SOUTHMILL BUILDING WINDOWS

Contents

ST. MICHAELS DEVELOPMENT,
MANCHESTER

Window Fenestration Studies
Southmill Building Windows

Subcontractor drawings
(Current condition - as installed)
Southmill Building Windows

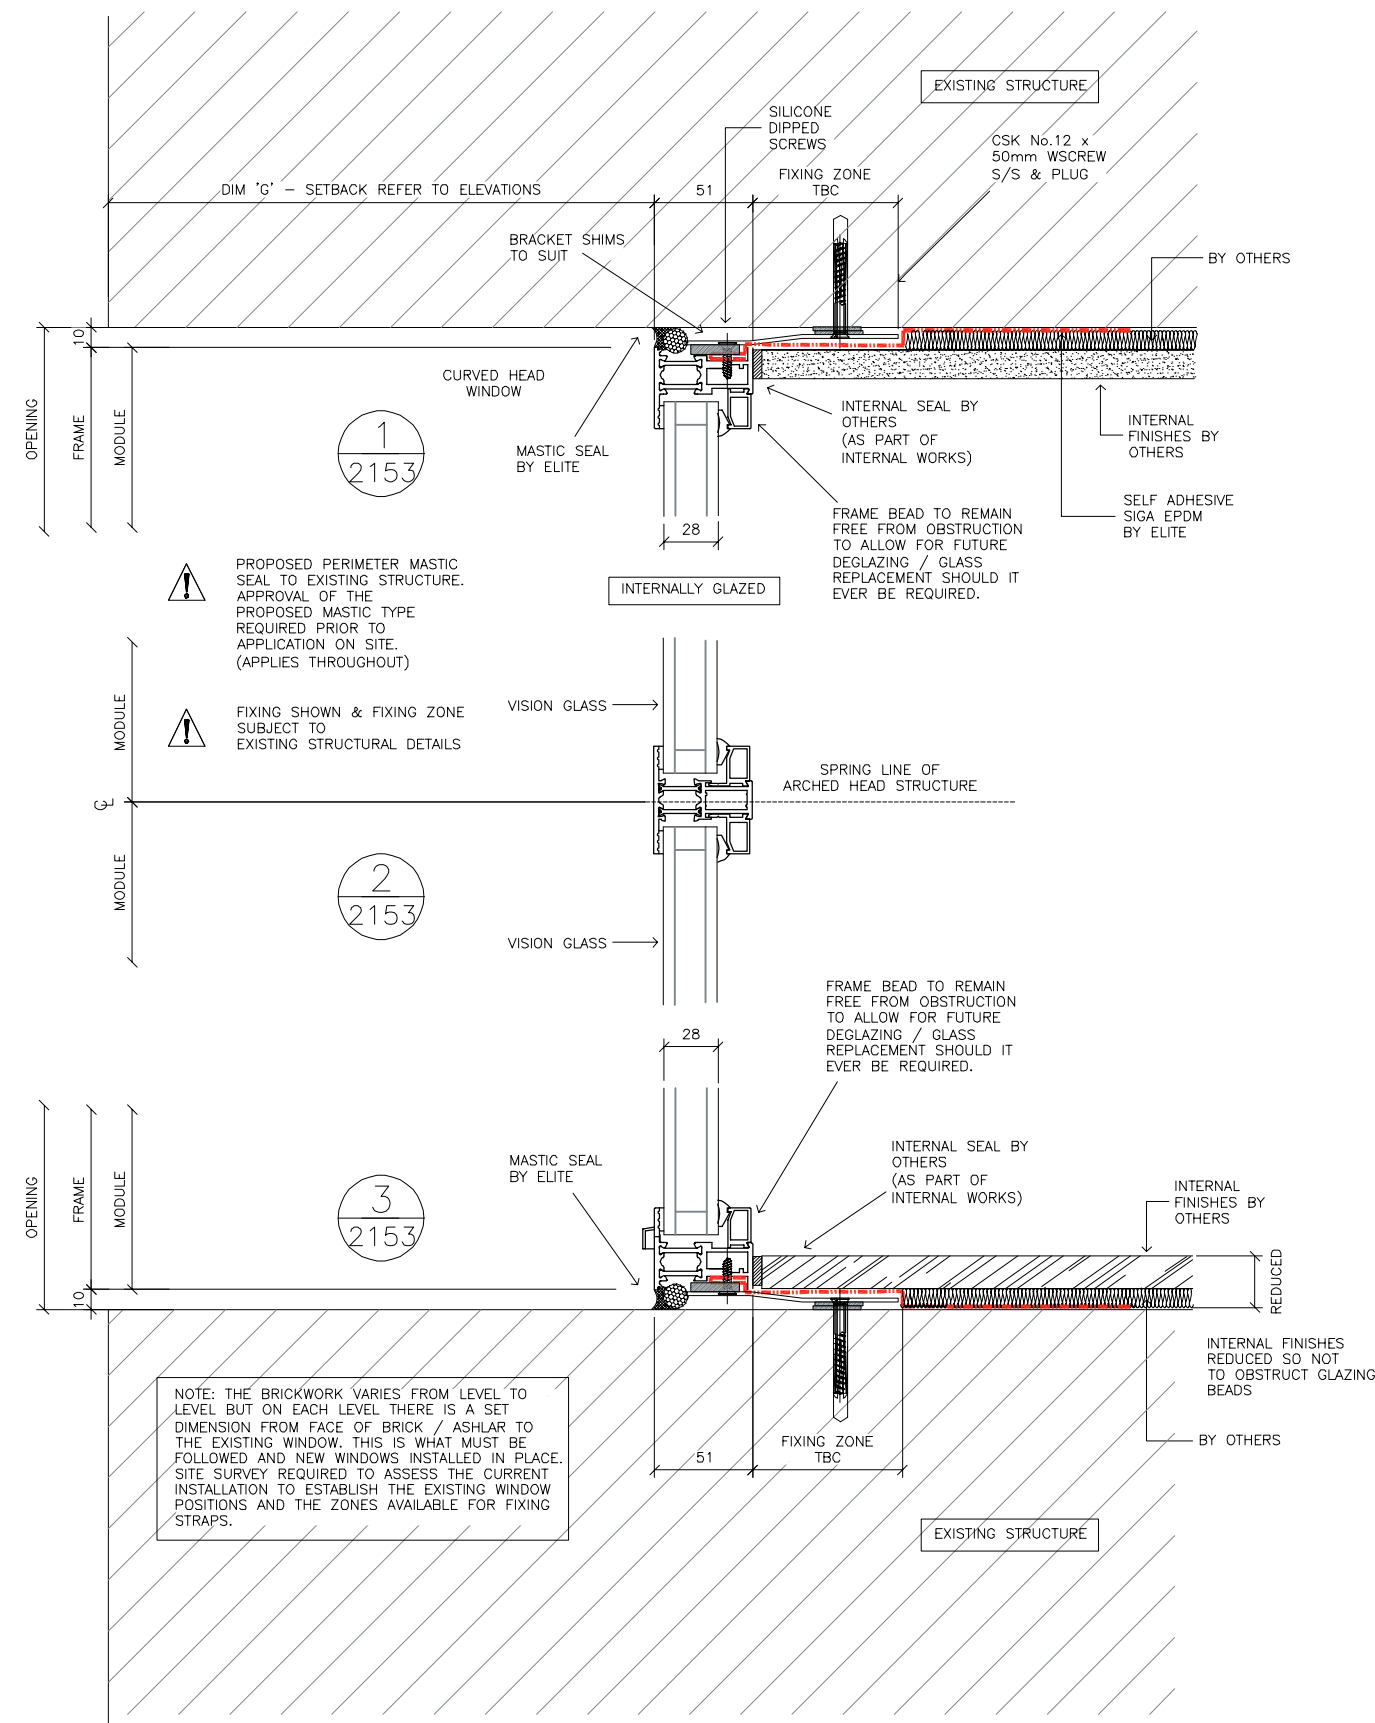
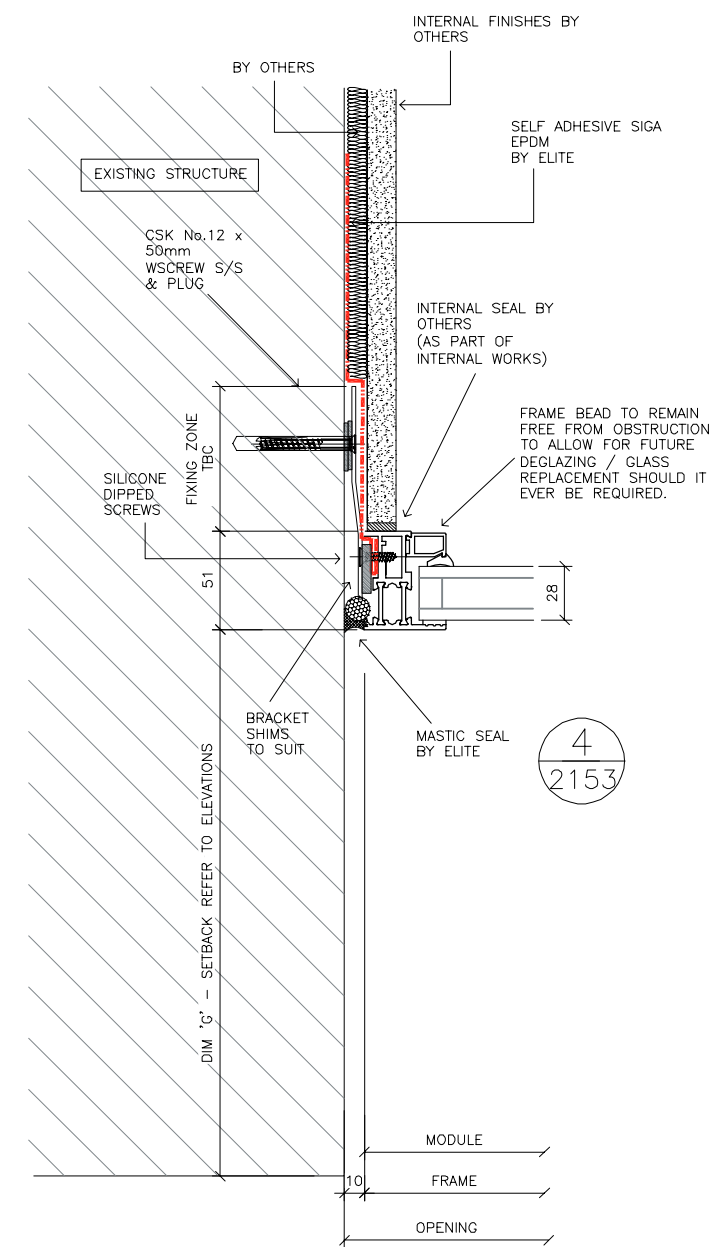
MCC have raised concern re the 'flatness' of the metal frame against the glazing

CGI studies (post commentary from MCC Planning Authority)

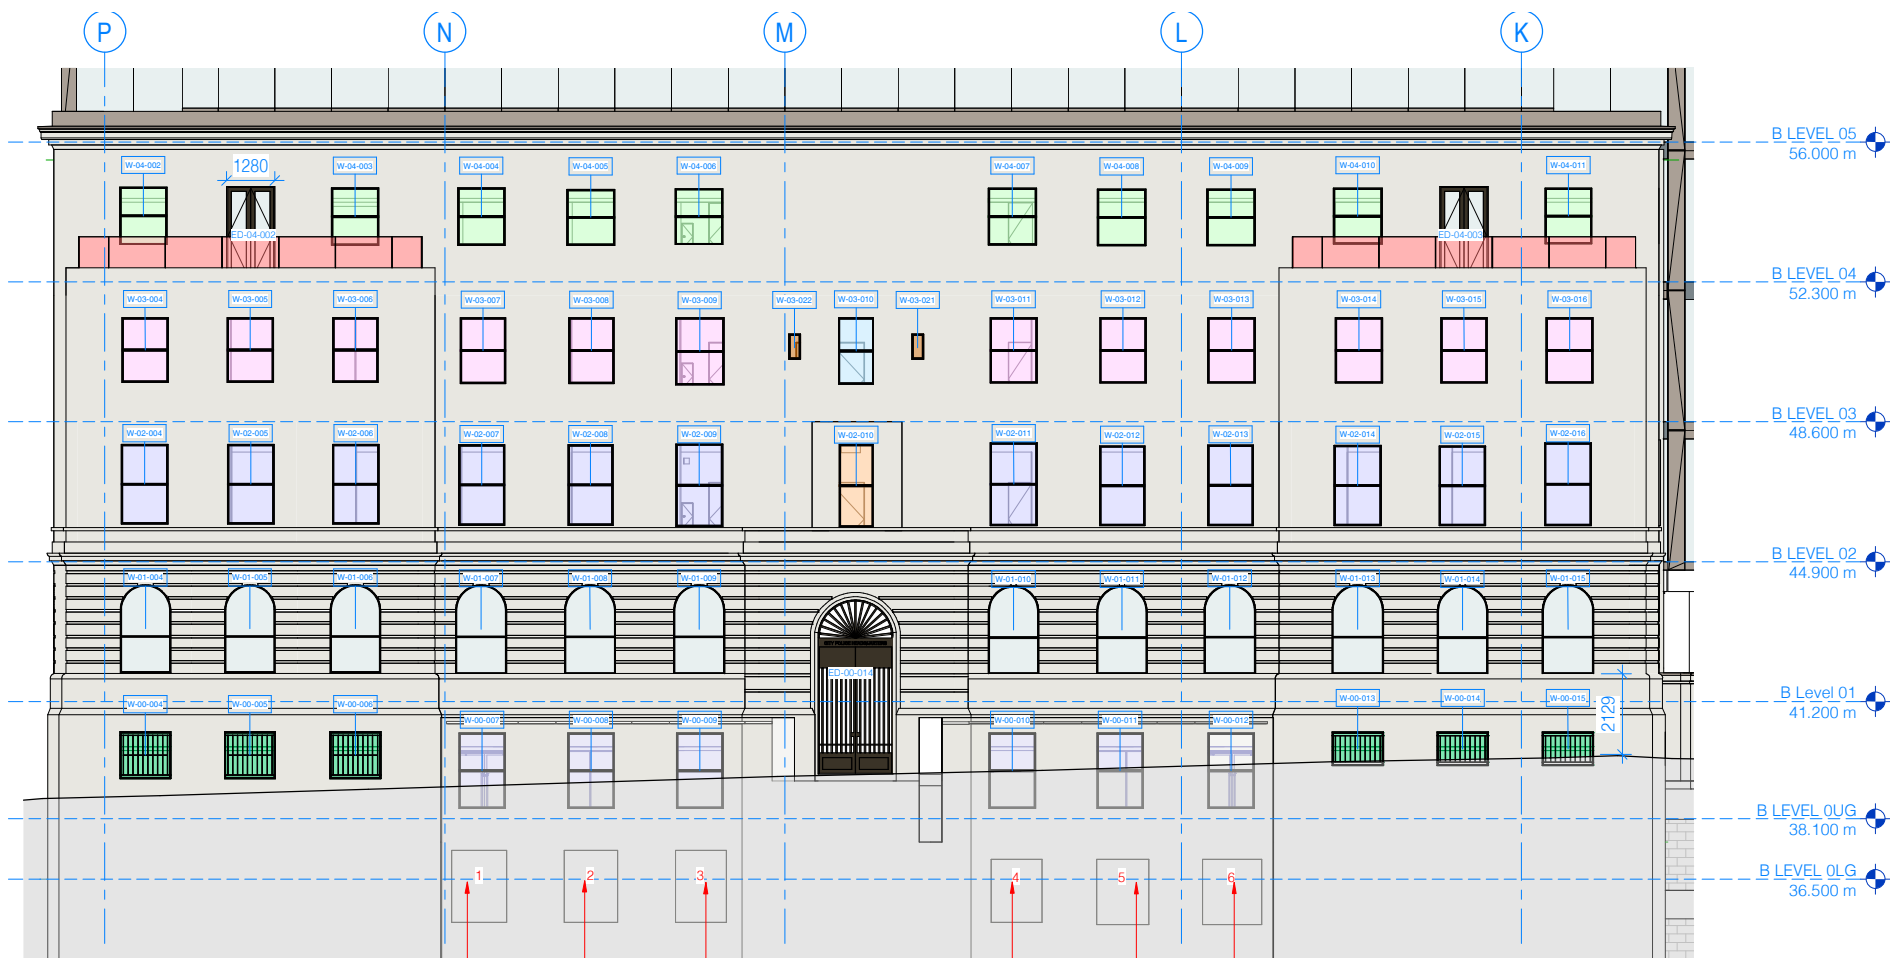
The following studies are in response to commentary from MCC Planning Authority upon presentation of the radial headed sample window

The response from the Design Team / B&K has been to:

1. Assess frame depth / external cap extrusion with the supplier put forward by B&K
2. Reduce the extent of the metalwork framing
3. Amend the proportions of glass / level of the horizontal transom to radial headed window

Lowered transom (low)
Vertical and splayed metal members removed

Lowered transom (mid)
Vertical and splayed metal members removed

Retained transom level (high)
Vertical and splayed metal members removed
